To: T10 Technical Committee
From: Steven Fairchild, HP (steve.fairchild@hp.com)
Date: 14 October 2003
Subject: SAS Discover Algorithm Modification

This proposal addresses two issues with the SAS Discover process as described in SAS 1.0.

Figure 2: Edge expander device set x1xx

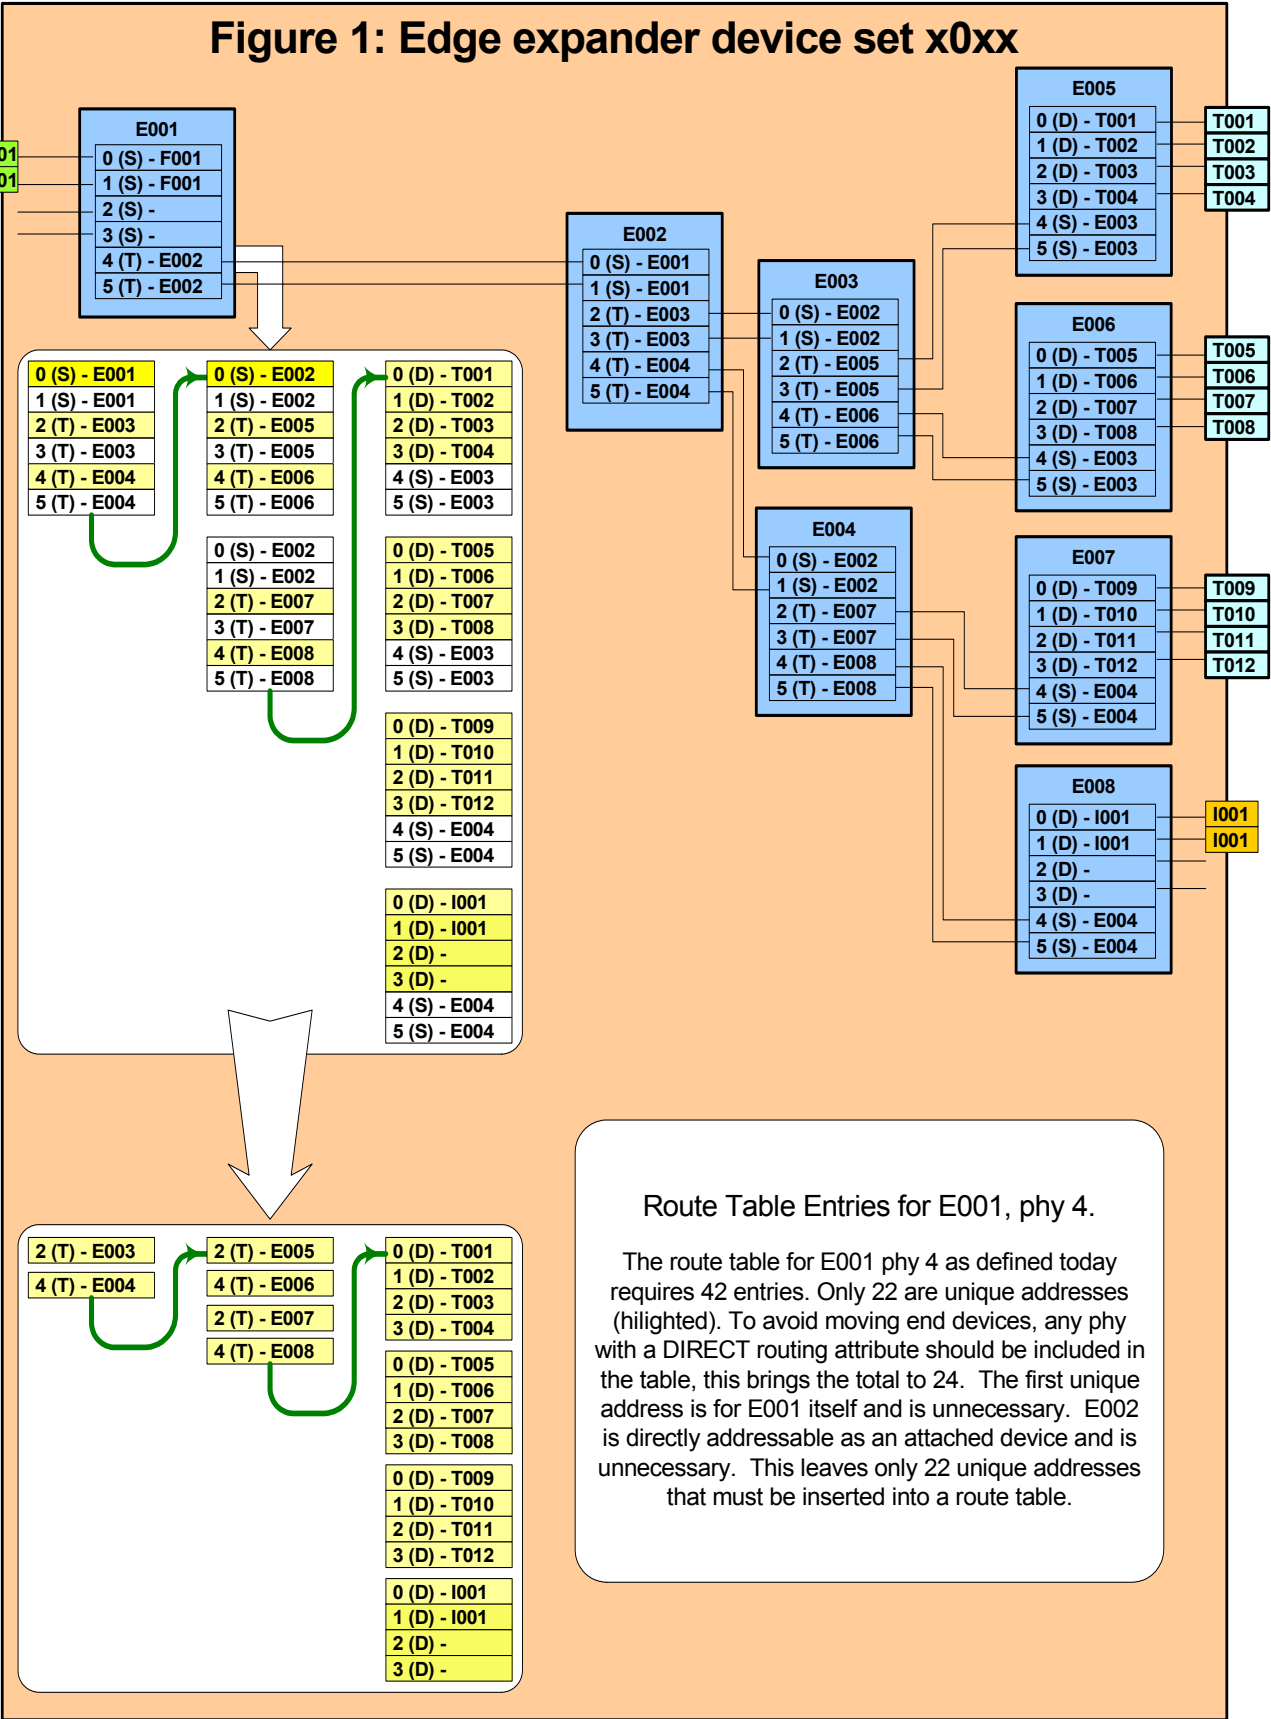
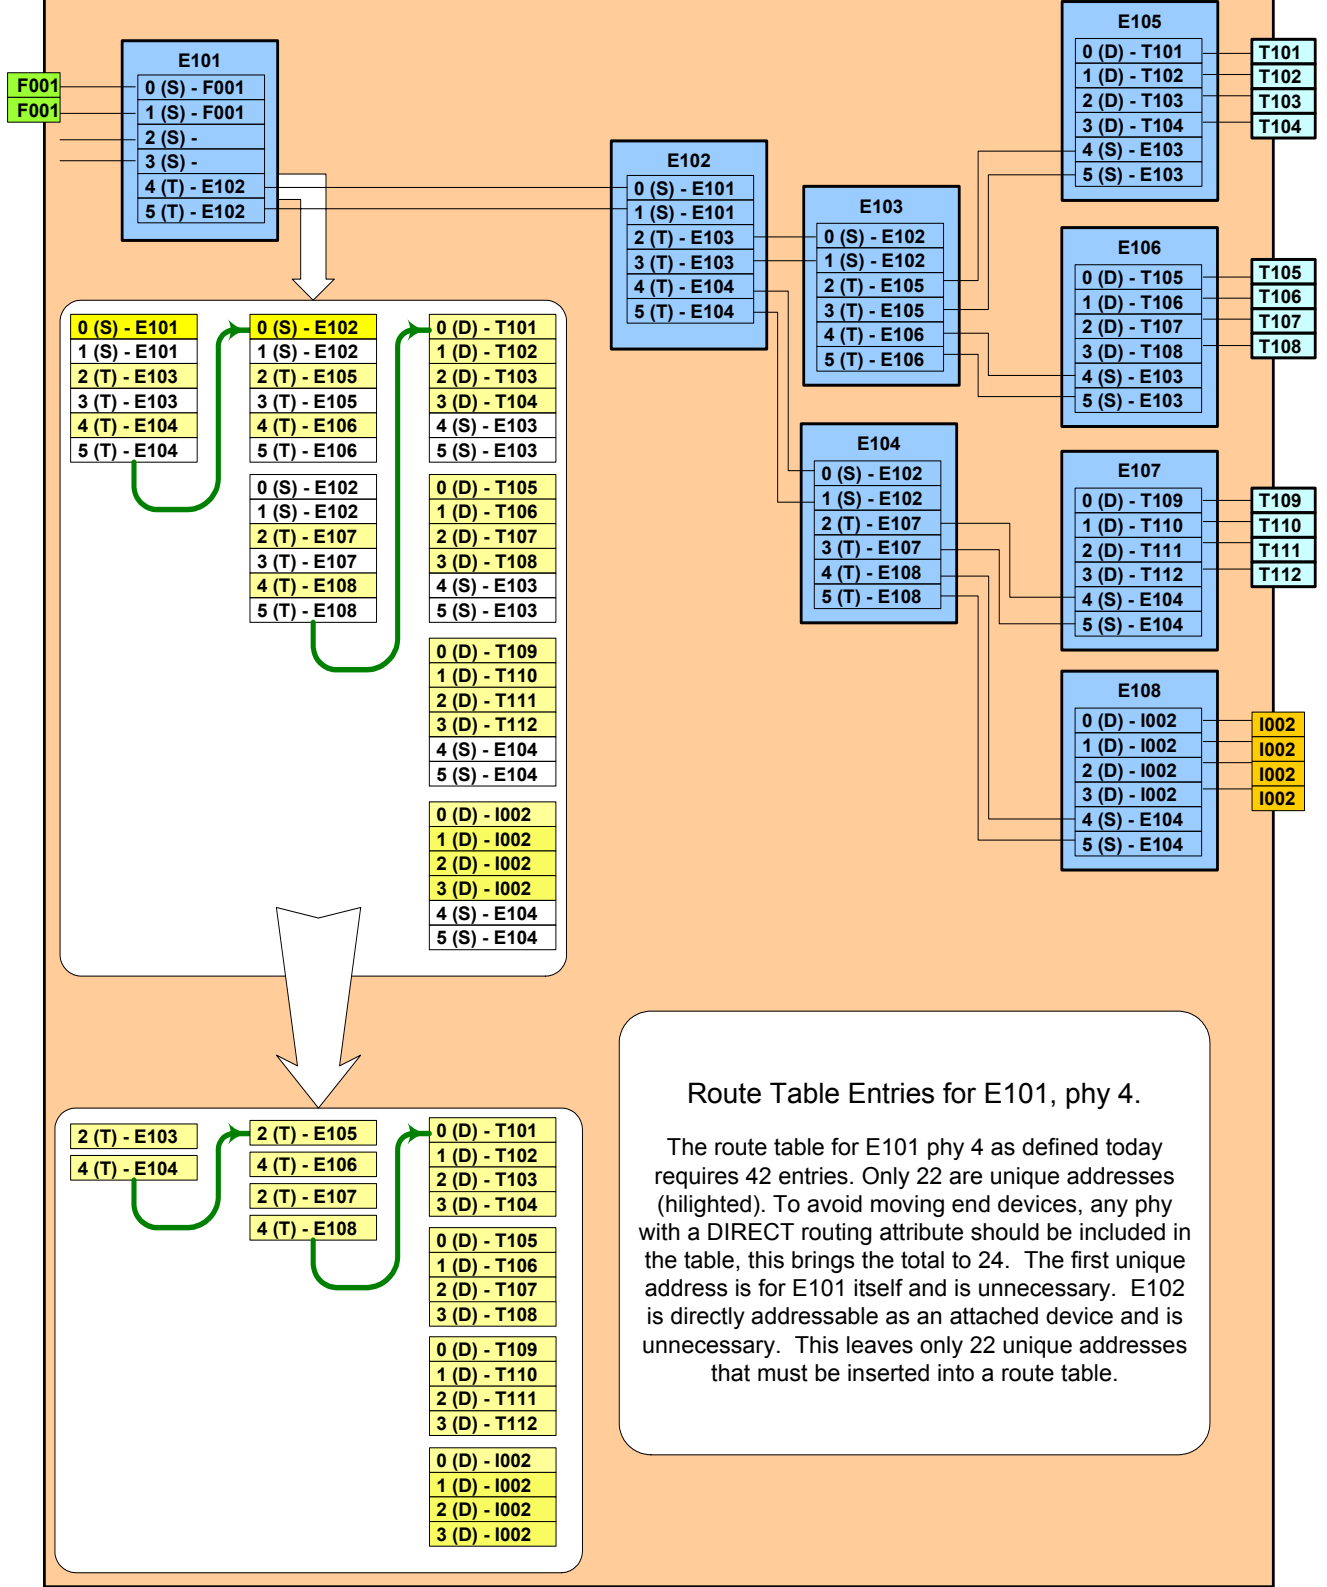
The diagrams at the end of this proposal illustrate the change in the route table entry layout.

Clarifying diagrams for the Discover process route table optimization.

Figures 1, 2 and 3 describe a topology that has two, edge expander device sets connected with a fanout expander. Each figure shows the original route table contents and the optimized route table contents.
